Electric Power Generation, Transmission, and Distribution; Electrical Protective Equipment; Corrections

ACTION: Correcting amendments.

SUMMARY: On April 11, 2014 (79 FR 20316), the Occupational Safety and Health Administration published a final rule: Revising the general industry standards for electric power generation, transmission, and distribution work and for electrical protective equipment; revising the construction standard for electric power transmission and distribution work; and adopting a new construction standard for electrical protective equipment. The final rule updated those standards and made the general industry and construction standards consistent. This document corrects errors in the preamble and regulatory text of the final rule.

Table R–3—AC Live-Line Work Minimum Approach Distance

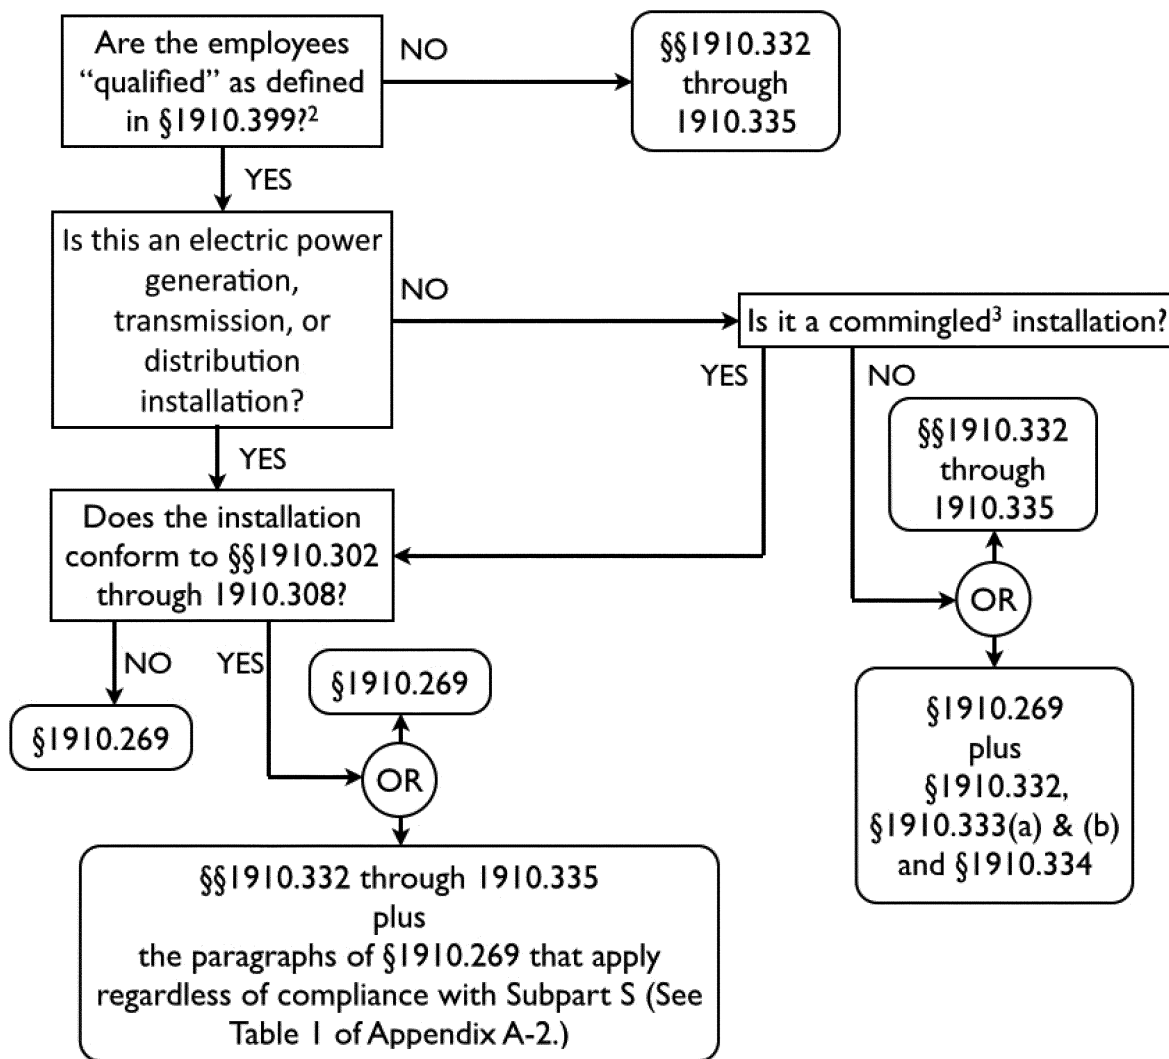
■ i. Under the entry “For phase-to-phase system voltages of more than 72.5 kV, nominal”, in the thirteenth row, revise the equation;

■ ii. In footnote 2, revise “Table 6 through Table 13” to read “Table 14 through Table 21”;

MAD = 0.3048(C + a)V_{L-G}TA + M
